### TENTATIVE AGENDA STATE AIR POLLUTION CONTROL BOARD MEETING

•	Mountain Valley Pipeline, LLC Lambert Compressor Station Registration No.: 21652 - Stationary Source Permit to Construct and Operate	Jenkins	
	Board Memorandum		C see pg. 23
	Draft Permit (Clean Copy)		Dsee pg 31
	Draft Permit (With Track Changes)		E see 88, 5
	Engineering Analysis		F See 08. 83
	Air Quality Analyses Review		GSeeps 121
	Public Participation Report (including representative sample of written comments)		H see ps, 127
	Summary of and Response to Public Comments		1 see ps. 131
	Staff Presentation		
	Public Comment in accordance with Board policy		
Recess	for Dinner - 5:30 p.m.		
Reconv	ene - 6:30 p.m.		
	Public Comment on Lambert Compressor Station in accordance with Board policy - continued		
ADJOU COMP	JRN - 9:45 P.M. OR WHEN PUBLIC COMMENT LETE, WHICHEVER IS EARLIER

# ATTACHMENT F - SUMMARY OF AND RESPONSE TO PUBLIC COMMENTS

#### LCS-28 Comment

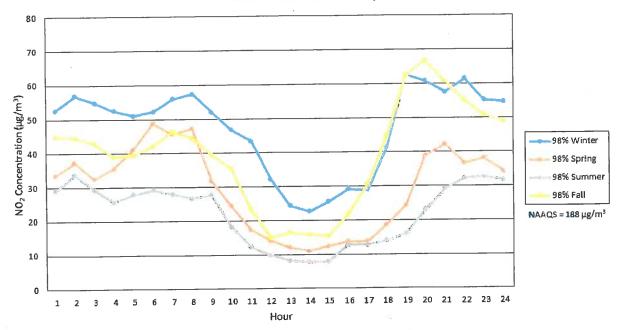
Commenters stated DEQ used an unsupported background concentration of 60.86 µg/m³ in the source contribution analysis "not identified as any of the 1-hour NO2 variable seasonal and hourly background concentration values presented in MVP's June 2020 Modeling Report."

Commenters stated the use of variable background NO2 monitoring data in the modeling was not justified.

**DEO** Response
